**BEFORE THE PUBLIC UTILITY COMMISSION
OF OREGON**

LC 66

2016 Integrated Resource Plan.

ORDER

Figure 1 – Revised Capacity Shortfall Graphic³²

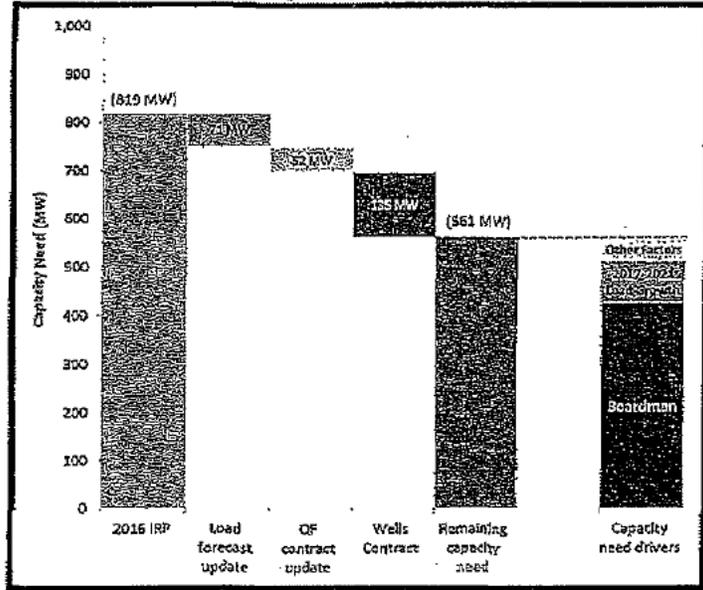
These above-mentioned events had two noteworthy impacts on the 2016 IRP. First, they reduced PGE's 2021 remaining capacity need to ~561 MW. Second, they extended PGE's need for Renewable Energy Certificates (RECs) for Renewable Portfolio Standard (RPS) compliance an additional four years into the future, from 2025 to 2029. Nonetheless, all of the Action Items in PGE's IRP remain largely unchanged. Most notably and concerning to Staff, PGE still continues to seek two categories of large resource acquisitions, one of which is for the primary purpose of meeting a distant regulatory compliance need, not a near-term actual energy or capacity need.
